Office Action Summary

10/539,133

WADA, KAZUSHI

DETAILED ACTION

FIG. 1

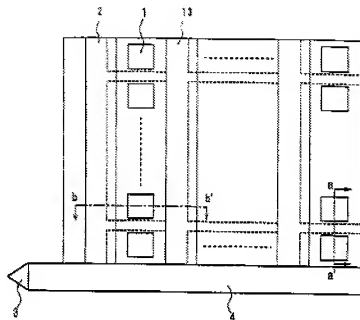
5. With respect to claim 1, Inagaki (e.g. Figure 1) teaches a solid state image pickup device **comprising:**

- **a semiconductor region 7 formed on a substrate 5** (Figures 2 and 3);
- a plurality of photo-sensors 1 **on the semiconductor region;**
- a transfer register 2 **formed in the semiconductor region which transfers** (column 6, lines 5-9) signal charges accumulated in said photo-sensors (column 5, lines 49-51); **and**
- an impurity region 13 (horizontal gridlines between adjacent photodiodes in vertical direction) **continuously** formed **in the semiconductor region** in a direction orthogonal to the transfer (vertical) direction of said transfer register (column 6, lines 39-52), **wherein,**
- said impurity region **is** provided at a position between said photo-sensors 1 adjacent to each other along the transfer direction of said transfer register **in the semiconductor region**

10. With respect to claim 7, Inagaki (e.g. Figure 1) further teaches a second barrier layer 13 (vertical gridlines between adjacent photodiodes in horizontal direction) (column 6, lines 39-52) comprised of an impurity region portion formed along said transfer register.
